TfNSW reference: REN25/00016/002

SSD-59155459, Merino Solar Farm; Response to Environmental Impact Statement

This attachment relates to TfNSW's response dated 9 March 2026 reference REN25/00016/002.

Figure 3: Vehicle chassis outline on raised median (indicated with blue oval) at Ottiwell Street/Braidwood Road/Bungonia Road, Goulburn. (Source: Appendix A of TIA)

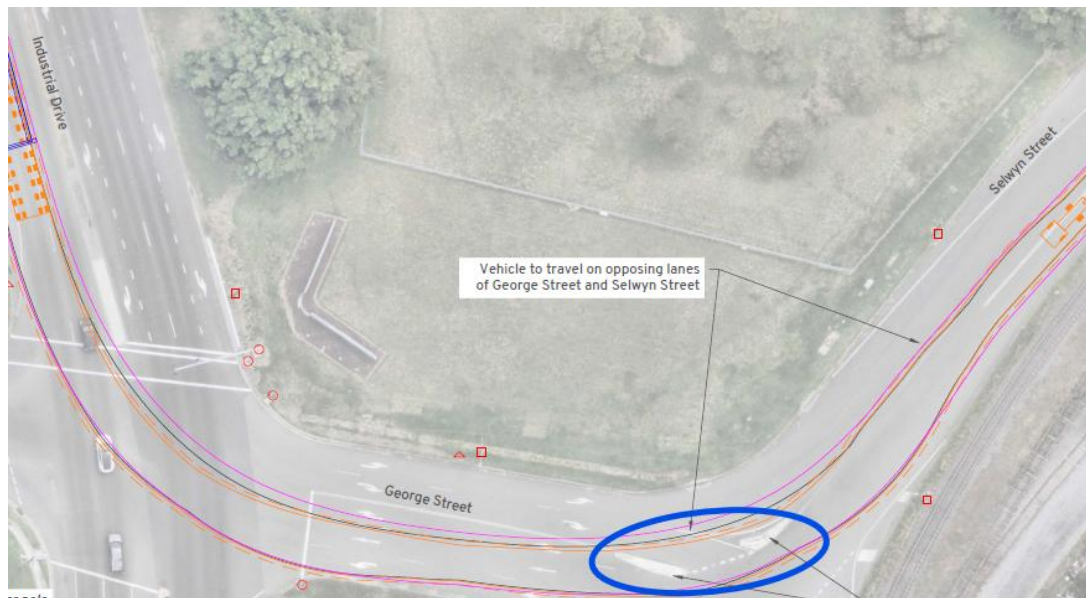
There are multiple instances of swept paths showing the vehicle chassis traversing outside of the paved road area and/or onto raised medians, including, but not limited to, at:

- Braidwood Road/Sloane Street, Goulburn,
- Ottiwell Street/Braidwood Road/Bungonia Road, Goulburn,
- Industrial Drive/George Street/Selwyn Street, Mayfield North, and
- Hawksbury Rest Area (Pacific Highway), Mooney Mooney.

These examples are shown in Figures 2 – 5 below for ease of understanding. Note that these are just a few examples, and there may be additional instances across the OSOM route. It is the Proponent's responsibility to ensure that all vehicle movements are on sealed pavement.

For pinch points where medians are traversed: TfNSW requires revised swept paths and, if applicable, the scope of works in the form of a strategic concept design that identifies the removal or modification of the refuge islands, curbs or medians that would be required. Mountable curbs and medians are to be demonstrated to be suitable to withstand the mass of the OSOM within a revised TIA.
